National Electricity Transmission System Security and Quality of Supply Standard

Amendment Report GSR009

Review of Required Boundary Transfer Capability with Significant Volumes of Intermittent Generation

Prepared by the SQSS Review Group for submission to the Authority

Figure F1 Boundary allowance

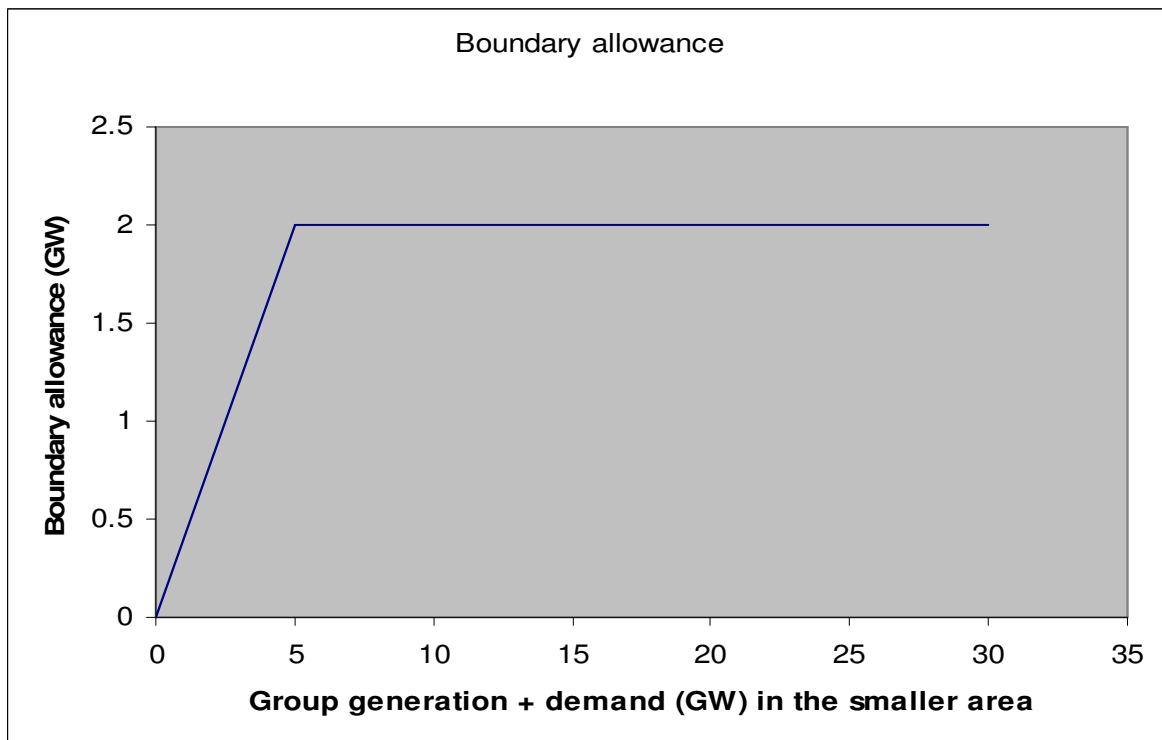
- F.3.2 using Figure F.1 to determine the *boundary allowance* (in MW)
 - F.3.3 finding the total active power generation output and total demand in each part of the system when applying the *boundary allowance* or half *boundary allowance* (as appropriate) as described in paragraphs F.4 and F.5;
